STRUMWASSER & WOOCHELLP

January 28, 2014

RE: Agenda Item 7-A. Introduction and First Reading of an Ordinance approving the Proposed Development Agreement 10DEV-002 to allow a mixed-use project totaling 765,095 square feet consisting of 473 rental housing units, 25 artist work/live units, approximately 374,434 square feet of creative office space, approximately 15,500 square feet of restaurant space, and approximately 13,891 square feet of retail space at 1681 26th Street; Certify the Final Environmental Impact Report prepared for the project in accordance with CEQA; and adopt a Resolution adopting the Mitigation Monitoring Program, Necessary CEQA Findings, and Statement of Overriding Considerations for the project

# **EXHIBIT E**

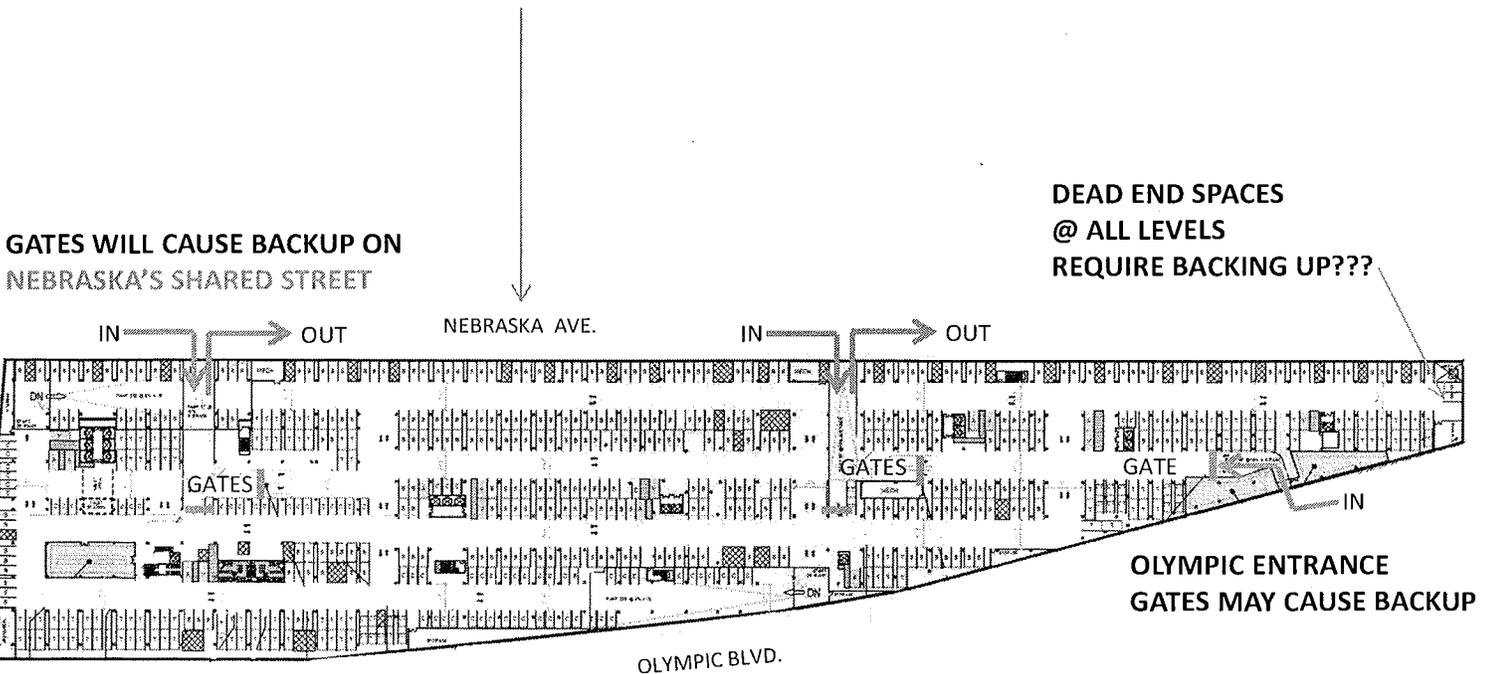
1,950 CARS ARE ENTERING & EXITING ON A SHARED STREET COMBINING CARS, PEDESTRIANS, CYCLISTS, & BABY STROLLERS  
 BTV PLAN STATES :

*"PROJECT DESIGN SHOULD MINIMIZE THE INTERACTIONS BETWEEN VEHICLES AND PEDESTRIAN/BICYCLE ACTIVITY"*

CARS WILL TRAVEL INSIDE THE GARAGE UP TO ½ MILE TO REACH A PARKING SPACE
